Application No.	Applicant(s)
Notice of Allowability	10/828,312	CHEN ET AL.
	Examiner	Art Unit
	Jerrold Johnson	3728
The MAILING DATE of this communication appears on the cover sheet with the correspondence address All claims being allowable, PROSECUTION ON THE MERITS IS (OR REMAINS) CLOSED in this application. If not included herewith (or previously mailed), a Notice of Allowance (PTOL-85) or other appropriate communication will be mailed in due course. THIS NOTICE OF ALLOWABILITY IS NOT A GRANT OF PATENT RIGHTS. This application is subject to withdrawal from issue at the initiative of the Office or upon petition by the applicant. See 37 CFR 1.313 and MPEP 1308.

REASONS FOR ALLOWANCE

The relevant disclosure of Tanaka et al. US 6,629,777 is shown below:

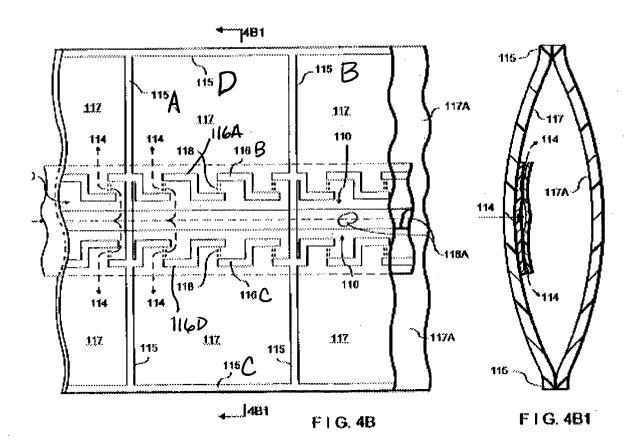
The New claims, which have been drafted by the Examiner, define over Tanaka et al. US 6,629,777 for the following reasons:

The seals that define the bladder are 115A-D. Coupling points 116A-D are disposed within the bladder and are spaced from the plurality of seals defining the bladder. Coupling points 116E are crossed by seals 115A or 115B and therefore are NOT spaced from the plurality of seals defining the bladder. Coupling points 116A-D, the coupling points that ARE spaced from the seals as claimed, do NOT couple the upper and lower films of the film check valve to the upper sheet 117 as is claimed. The coupling points 116A-D only couple the upper and lower films of the film check valve to each other. The film check valve is described as "floating", and from col. 12, lines 1-6, it is clear that the connection of the film check valve to the sheets of the bag are NOT made through the coupling points, as is claimed.

The inventive concept set forth in claim 21 is that the coupling points 34 are both spaced from the seals 31,35 which define the bladder AND couple both the upper and lower films 25,26 together as well as couple the films to the upper sheet 21. This concept is not disclosed in the prior art of record.
